OB-8

SCHEMATIC 1679A SHEET 2

OBERHEIM ELECTRONICS, INC.
ENGINEERING CHANGE ORDER

ECO NO
406

<p>PRODUCT AFFECTED</p> <p>OB-8</p>	<p>DRAWINGS AFFECTED</p> <p>PROCESSOR BOARD 1679B SHEET 1 OF 4</p>
-------------------------------------	--

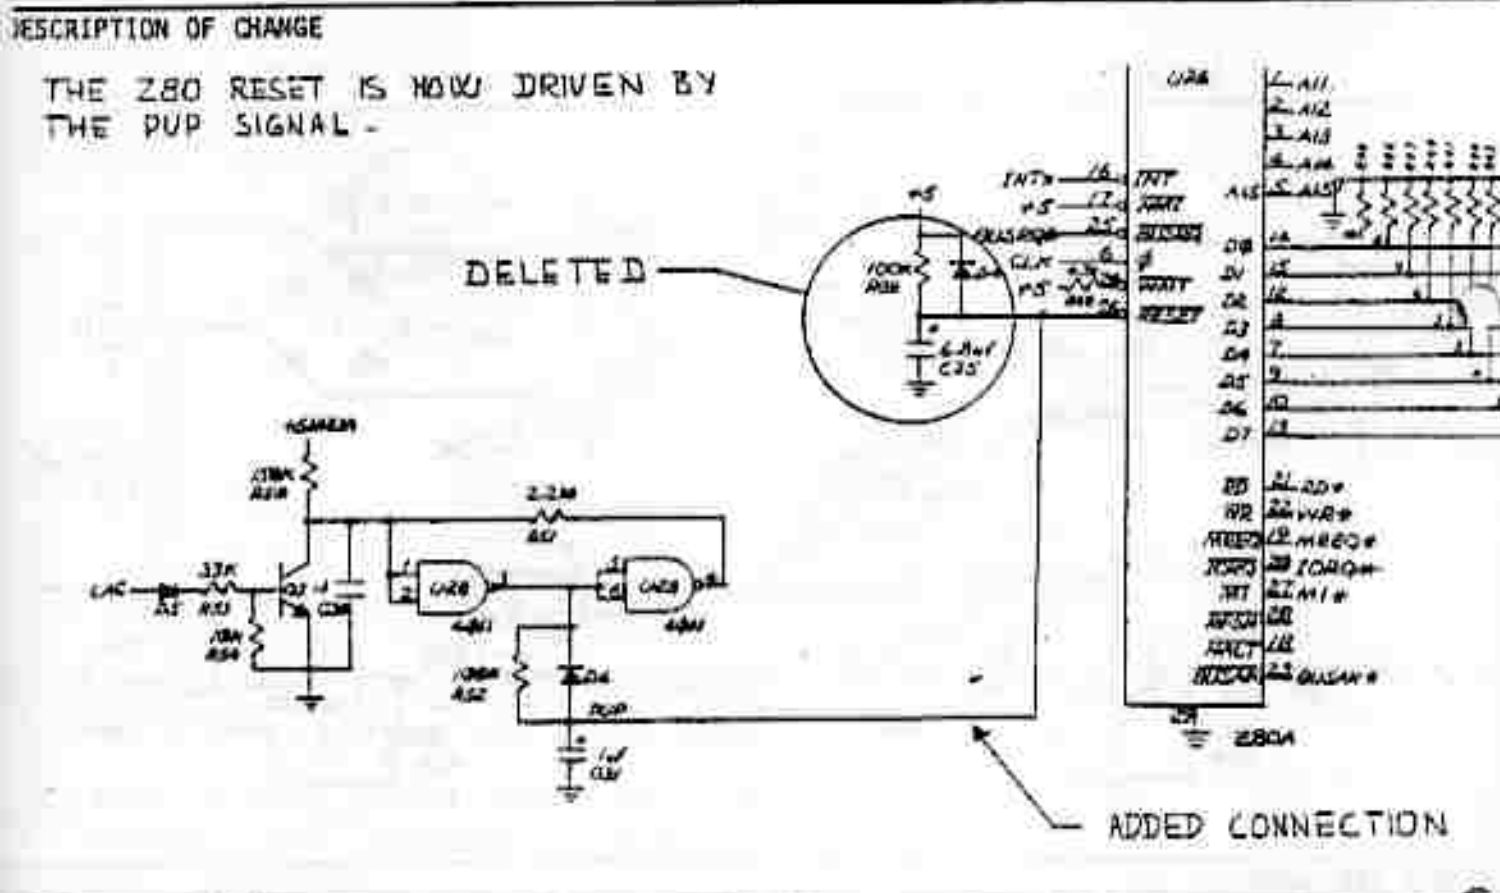
TO AVOID POSSIBLE MEMORY DROP CAUSED BY SHORT POWER DROP

DRAWINGS AFFECTED
POWER SUPPLY

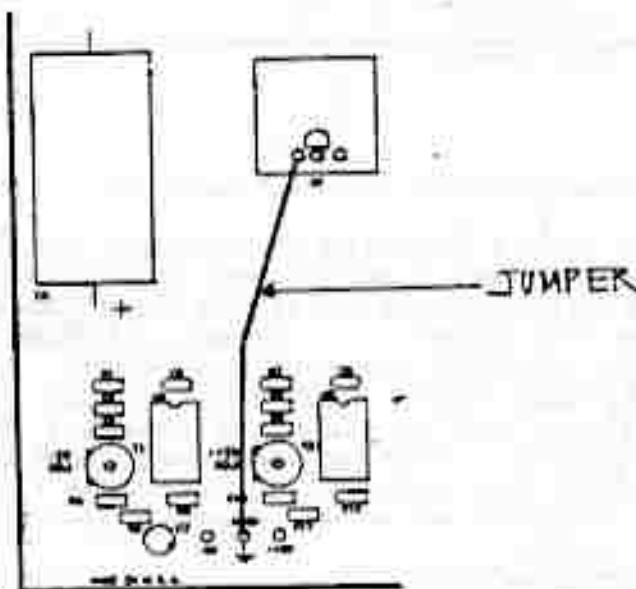
ADD A JUMPER BETWEEN PIN 1 OF THE -15 REGULATOR
7915 (GND) AND THE GROUND REFERENCE TEST POINT.
THE JUMPER MUST BE MADE OF A 18 AWG WIRE (.04 inch / 1 mm)
MINIMUM AND MUST BE SHORT.

TO REMOVE AC HUM ON AUDIO OUTPUT.

OB-8 PROCESSOR BOARD 1679B sheet 1 of 1

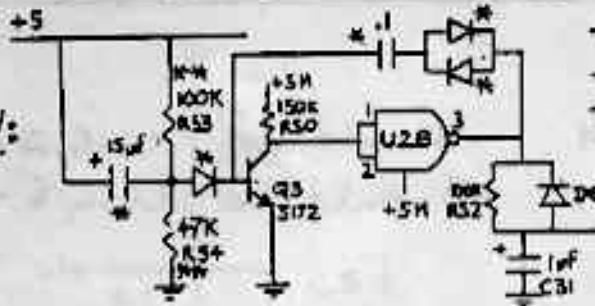
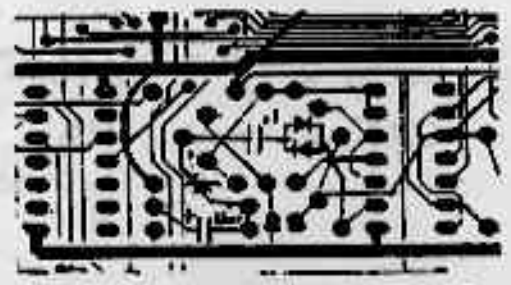
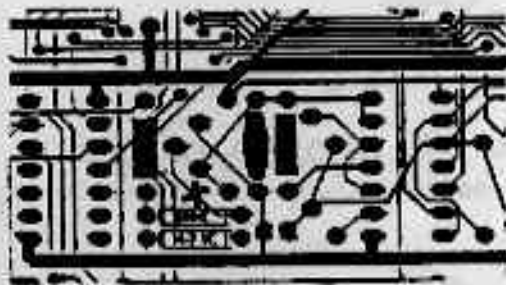
NEW PUP CIRCUITRY:

PUP To memory protect and processor reset (see ECO #424)

- Remove D5, C30, R31 (darkened components)
- Cut between Q3 base and R53
- Remove diode added by ECO #23 (under the board)
- Replace R53 with a 100K and R54 with a 47K

- Add a jumper between +5 and R53
- Add from under the board: 2 caps and 3 diodes

- Replace C1 (4700µF cap. on 5v power supply) with a 10,000µF 16v

- Avoid memory drop.

ECO # 419

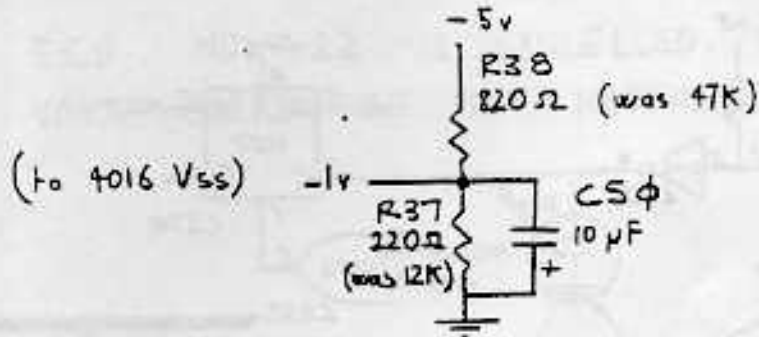
- change value of -1 divider on each voice board

- ALLOWS USE OF SIGNETICS' 4016 &
IDENTIFIES COMPONENTS

08-8 MOD CAN SCHEMATIC
SHEET 1 OF 1.

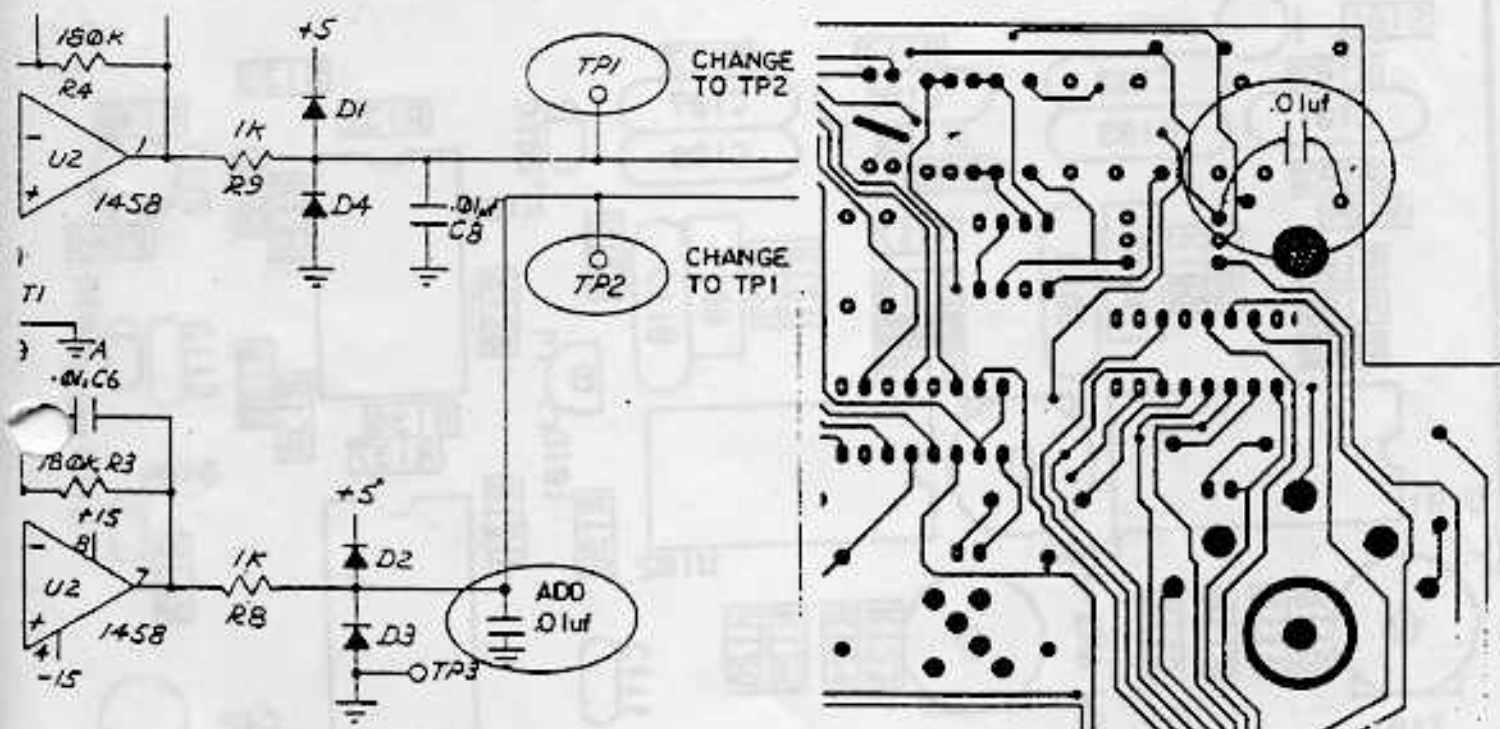
REMOVE NOISE MODULATION FROM
VIBRATO LEVER, AND CORRECT
SCHEMATIC.

1. CHANGE SCHEMATIC AS SHOWN.
2. ADD .01uf CAP (08.153004) FROM GROUND TO TEST POINT (T.P. 2) OF MOD CAN PCB ON 1666 SIDE OF BOARD.

DRAWINGS AFFECTED VOICE BOARD
SCHEMATIC 1682B SHEET 3 OF 3

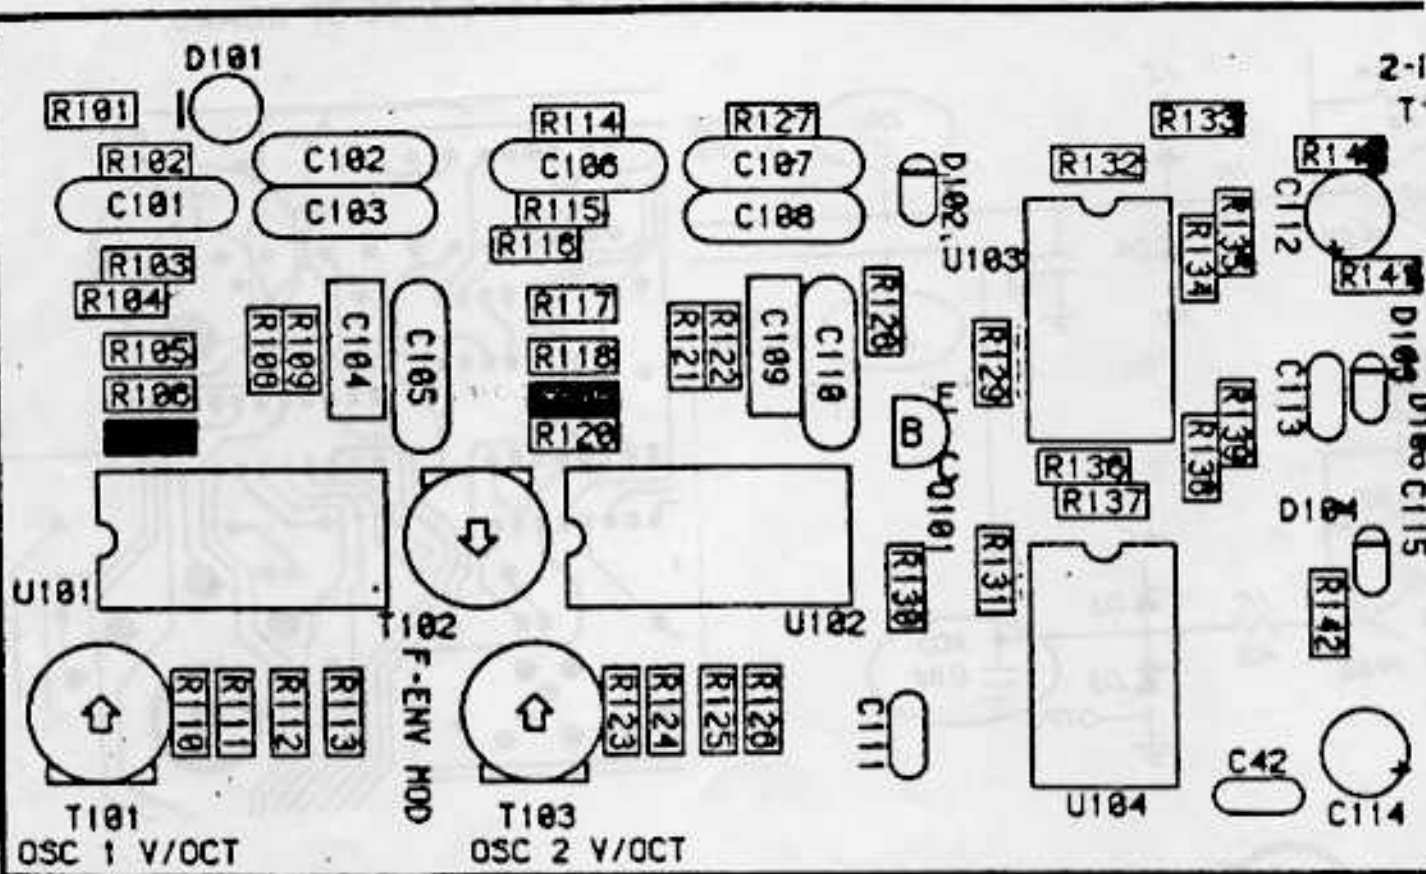
LOWER INITIAL FREQUENCY OF 3340
TO ACCOMMODATE A WIDER RANGE
OF CHARACTERISTIC VARIATIONS ON
THE 3340.

REPLACE RESISTOR RX07 AND RX19 (215K, 1%)
WITH 174K, 1% (OB#475520).
